GROUP Service Campaign	MODEL 2011~2015MY Optima (TF) 2011~2015MY Optima Hybrid (TF HEV) 2009~2010MY Rondo (UN) 2009~2014MY Sedona (VQ)
	NUMBER SC135	DATE September 2016
VOLUNTARY EMISSIONS SERVICE CAMPAIGN		
SUBJECT: EVAPORATIVE CANISTER INSPECTION AND/OR REPLACEMENT (SC135)

EVAPORATIVE CANISTER INSPECTION AND/OR REPLACEMENT

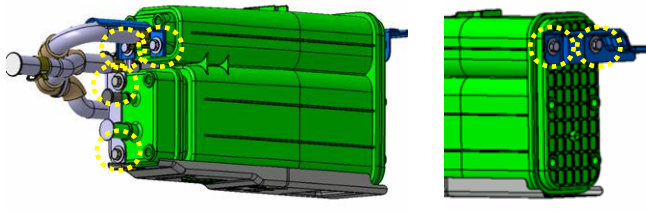
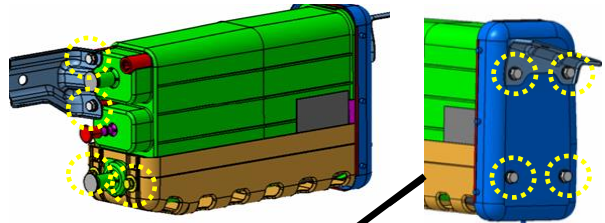
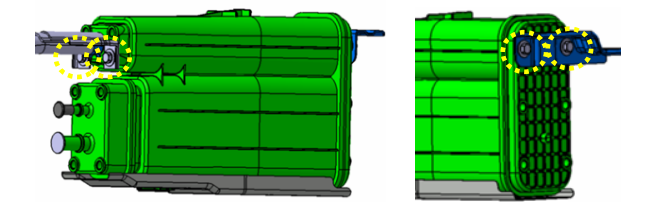
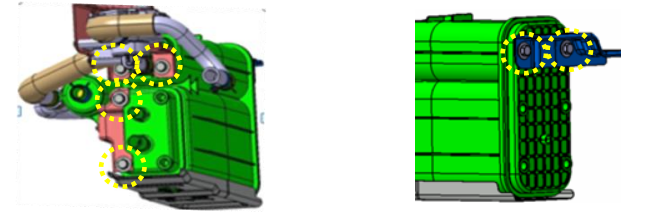
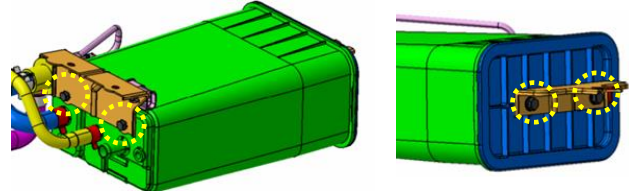
3. Clean all insert nuts using a metal brush and shop air. See diagram on page 3 for specific thread insert locations requiring cleaning. Inspect all insert areas of the charcoal canister (B) carefully for cracks (C), as shown in “Insert Area Crack Examples” table on the next page.

If no cracks are present, proceed to “Replace Bracket Kit” and discard all bolts and previously removed bracket which will not be reused.

If cracks are present, proceed to the “Canister Replacement” procedure and retain removed brackets for later reuse and only discard removed bolts.

Replace Bracket Kit Procedure:

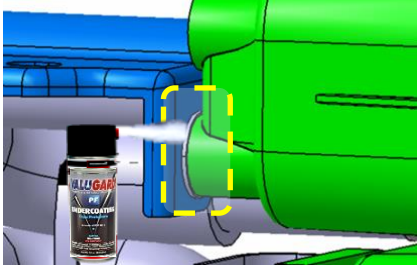
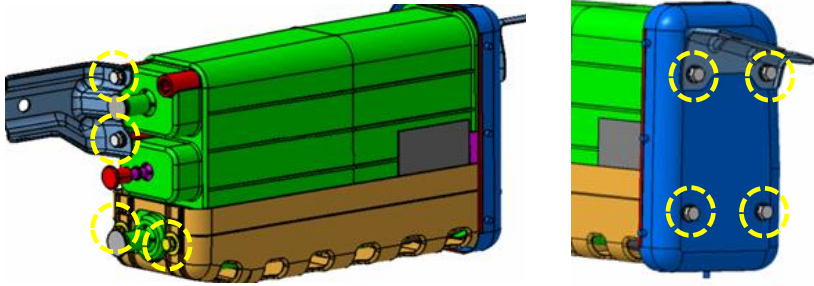
1. Refer to table on page 5 and install vehicle appropriate new bracket kit to the canister. Install in order of bolt → bracket → rubber washer → canister.

Tightening torque:

3.7 ~ 4.3 lb-ft (5.0 ~ 5.9 Nm)
